SF705 A-F

Subject: Espar Fuel Standpipe Weld

On behalf of the entities listed below, Daimler Truck North America LLC (DTNA), is initiating Field Service Campaign SF705 to modify the affected vehicles.

PROBLEM:	The steel fuel tank standpipes do not meet the previous brass standpipe durability and are breaking, causing the Espar heater not to function.
SOLUTION:	A Daimler Truck North America authorized service facility will inspect and install a new nickel-plated brass standpipe as needed.

Fig. 1, Brass Standpipe Installed in the Fuel Tank

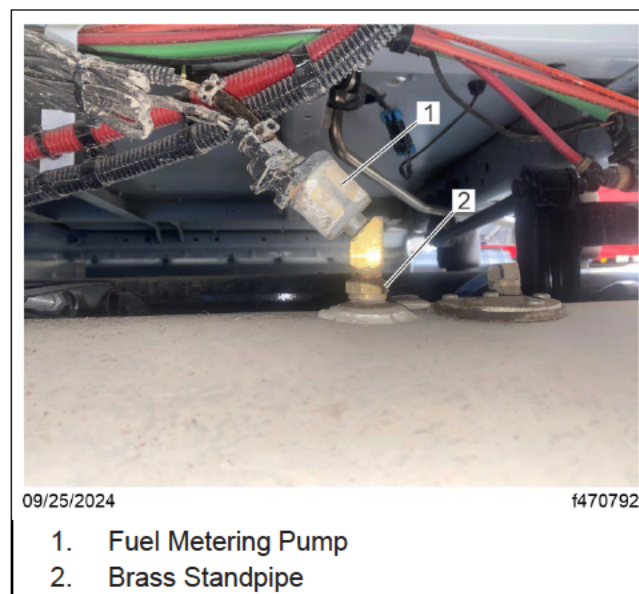
- ☐ If a brass standpipe is installed, as shown in [Fig. 1](#), no further action is required. Go to step 16.
 - ☐ If a nickel-plated steel (shiny/chrome at 7/8-inch hex) standpipe is installed, continue with step 6.

- 10.6. Position the fuel tank downward and out from under the cab just enough to easily remove the fuel standpipe.
 - NOTE: The replacement standpipe is made of nickel-plated brass or bronze and has a shiny chrome appearance at the 7/8-inch hex fitting. The updated base material is brass or bronze.

11. Replace the standpipe with a new one and apply a small amount of pipe sealant on the threads. Install the fuel metering pump and apply a small amount of pipe sealant on the threads while holding the standpipe hex with a 7/8-inch wrench. Position the fuel metering pump in the same location and direction as originally installed in step 6.
